POST AMALGAMATION MEETING 7 MINUTES

Venue: Rockhampton Regional Council, Dooley Street Office, Rockhampton

Date and Time: Thursday 27 November 2014
2:00pm – 5:00pm (tea and coffee provided)

a) Conical Pre-cast Sewer Access Chamber Base

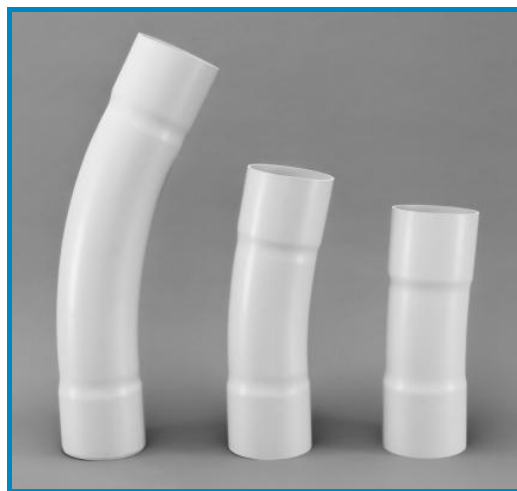
Provide Table of difference in Sewer Design and Construction Specification for approved use of Conical Chamber bases as per below.

Council	Conical Chamber Base
BSC	Not Approved
CHRC	Approved
GRC	Not Approved
LSC	Approved
MRC	TBC
RRC	Approved

MRC to confirm requirements.

a) Sewer Bends

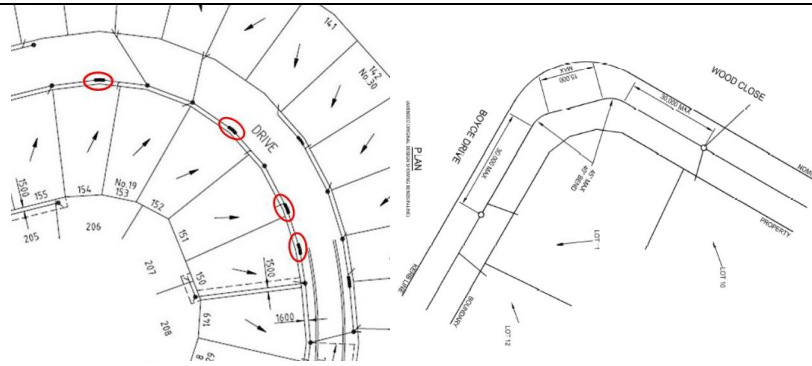
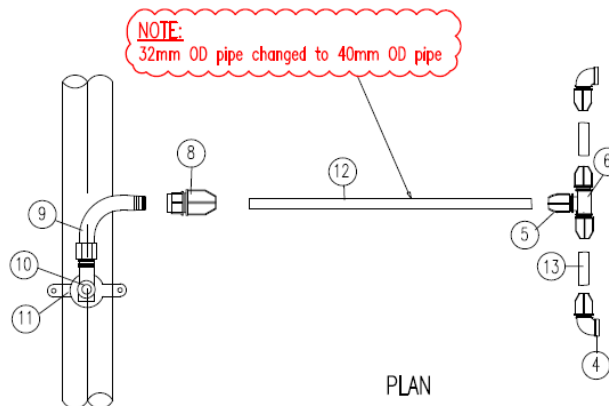
Examples of how to represent on drawings.

Provide Table of difference in Sewer Design and Construction Specification for approved use of horizontal bends in sewers as per below.

Council	Use of Horizontal Bends in Sewers
BSC	Not Approved
CHRC	Not Approved
GRC	Approved
LSC	Approved
MRC	Not Approved
RRC	Not Approved

Mike to provide wording for inclusion in the specification regarding the use of bends. Wording to include:

- Bends to be 'long radius' type'
- Max 2 bends per run
- 80m between manholes still required.
- Vertical bends not approved.

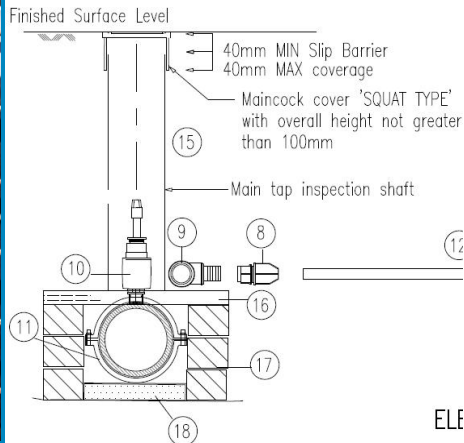
a) 32mm OD service connections (double) now 40mm to allow greater capacity for the construction of multi-unit dwellings.

Update Table of difference in Water Design and Construction Specification to include each Councils preferences for moving to 40mm OD double service connections as per above.

Council	Change to 40mm
BSC	TBC
CHRC	No
GRC	Yes
LSC	Yes
MRC	TBC
RRC	Yes

Table of difference D11.11.03 and Standard drawings to be updated appropriately.

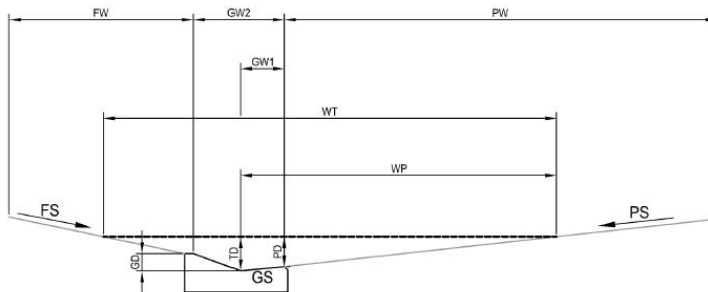
b) Interallotment / Roofwater Drainage – capture of roof runoff only (no requirements to capture overland runoff). Pits are not required in every allotment. Use of connection to interallotment main (similar to sewer) in place of pit.

- If depth of pipe is less than 2m, 45 degree & 60 degree bends are to be used – similar to sewer house connections.
- If depth of pipe is greater than 2m, 5 degree bends are to be used similar to sewer sugdun joint.
- All roof water house connection end caps to be marked ‘Roof Water Only’.
- All sewer house connections and caps to be marked ‘Sewer Only’.

Provide Table of Difference in Drainage Design specification for required level of Inter-allotment Drainage as per below.

Council	Required level of service (as per QUDM)
BSC	Level 2 – connection to main okay, no grated inlets
CHRC	
GRC	Level 3 (unless otherwise approved) – connection to pits
LSC	Level 2 – connection to main okay, no grated inlets
MRC	
RRC

Create standard drawing for connection to main. Leesa (BSC) to provide example drawing).
